ATTACHMENT 4 TO AEP:NRC:1071N

EXISTING TECHNICAL SPECIFICATIONS PAGES

MARKED-UP TO REFLECT PROPOSED CHANGES

DONALD C. COOK NUCLEAR PLANT

Figure 3.6-2: Donald C. Cook Nuclear Plant Schematic for Fuel Storage Racks Interface Boundary Between Regions 1 and 2

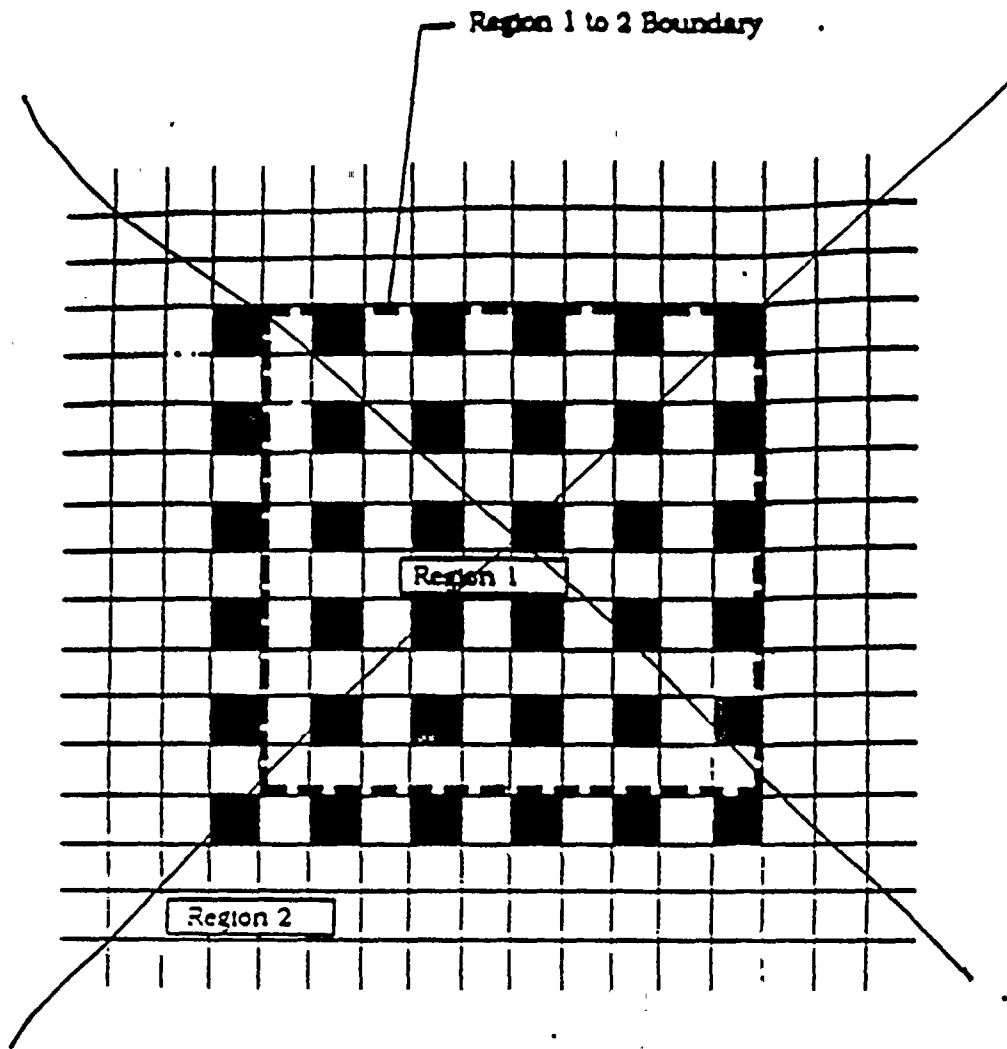
c. 1. A separate region within the spent fuel storage racks (defined as Region 1) shall be established for storage of Westinghouse fuel with nominal enrichment above 3.95 weight percent U-235 and with burnup less than 5,550 MWD/MTU. In Region 1, fuel shall be stored in a three out of four cell configuration with one symmetric cell location of each 2 x 2 cell array vacant.

3. The boundary between the Region 1 mentioned above and the rest of the spent fuel storage racks (defined as Region 2) shall be such that the three out of four storage requirement shall be carried into Region 2 by, at least, one row as shown in Figure 5.6-1.

INSERT A: Types of enrichments greater than 3.95 weight percent U-235 and burnup less than 5,550 MWD/MTU in a checkerboard pattern configuration alternating Category 1 and Category 2 fuel as shown

in Figure 5.6-1.

Westinghouse Category 1 and Category 2 fuel definitions are given in Figure 5.6-2.

NEW FIGURE

Figure 5.6-1: Donald C. Cook Nuclear Plant Schematic for Fuel Storage Racks Interface Boundary Between Regions 1 and 2

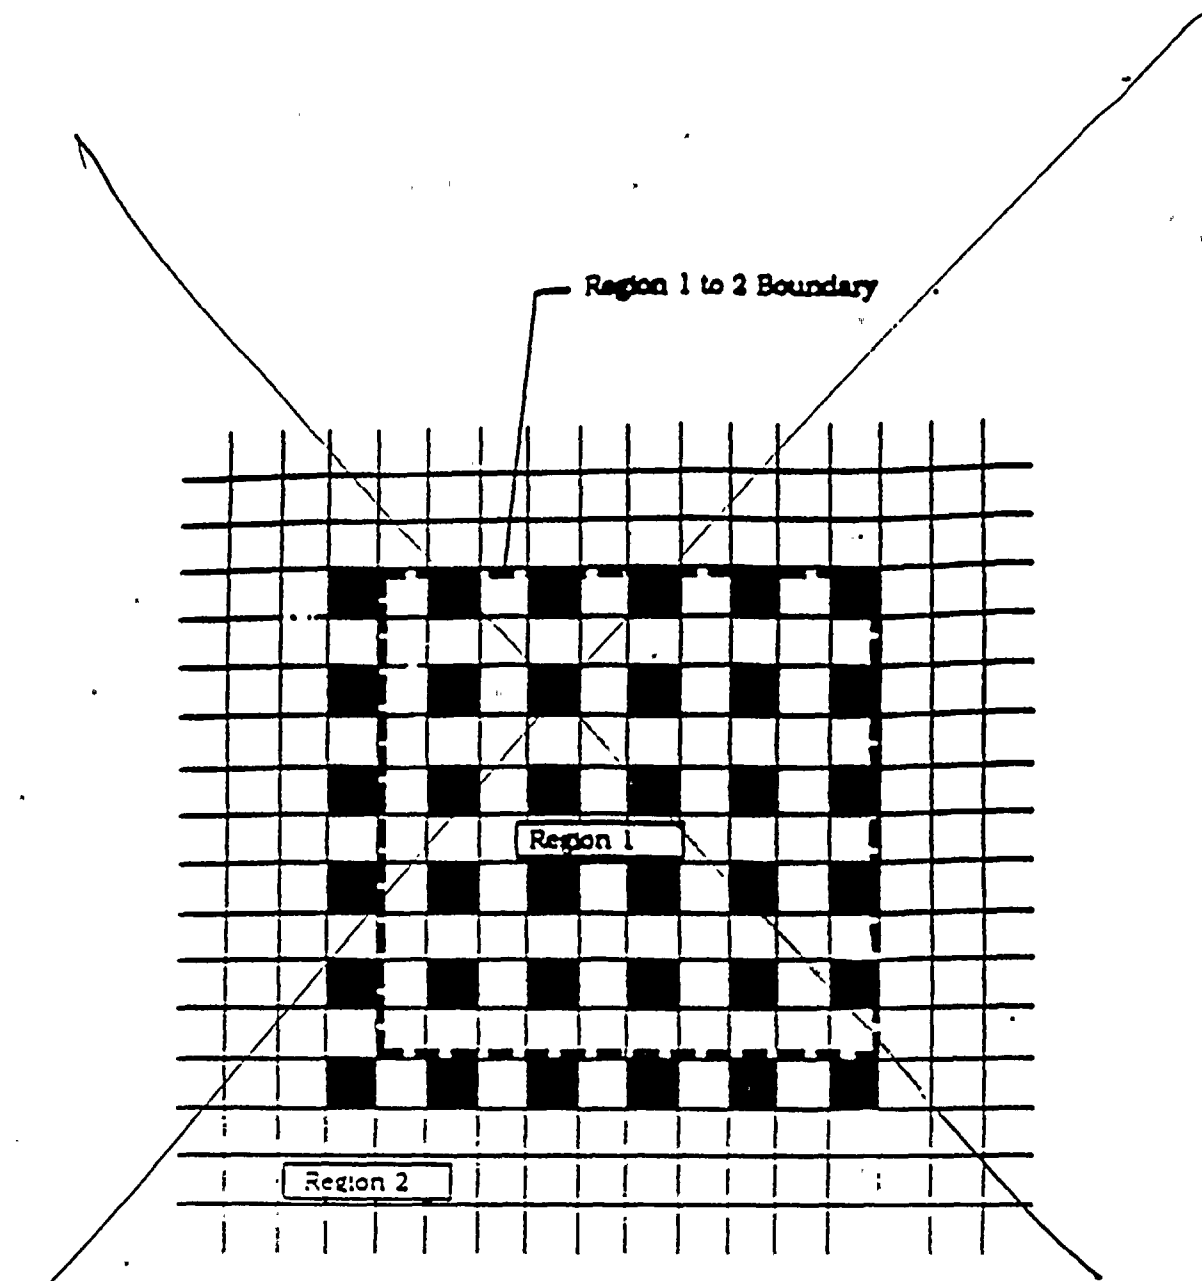
- a. A K_{eff} equivalent to less than 0.95 when flooded with unborated water.
- b. A nominal 10.5-inch center-to-center distance between fuel assemblies, placed in the storage racks.
- c. 1. A separate region within the spent fuel storage racks (defined as Region 1) shall be established for storage of Westinghouse fuel with nominal enrichment above 3.95 weight percent U-235 and with burnup less than 5,550 MWD/MTU. In Region 1, fuel shall be stored in a three out of four cell configuration with one symmetric cell location of each 2 x 2 cell array vacant.
2. INSERT B and 2
3. The boundary between the Regions mentioned above and the rest of the spent fuel storage racks (defined as Region 2) shall be such that the three out of four storage requirement of Region 1 shall be carried into Region 2 by at least, one row as shown in Figure 5.6-1. checkerboard pattern

INSERT A: types of enrichments greater than 3.95 weight percent U-235 and burnup less than 5,550 MWD/MTU in a checkerboard pattern configuration alternating Category 1 and Category 2 fuel as shown in Figure 5.6-1. Westinghouse Category 1 and Category 2 fuel definitions are given in Figure 5.6-2

NEW FIGURE
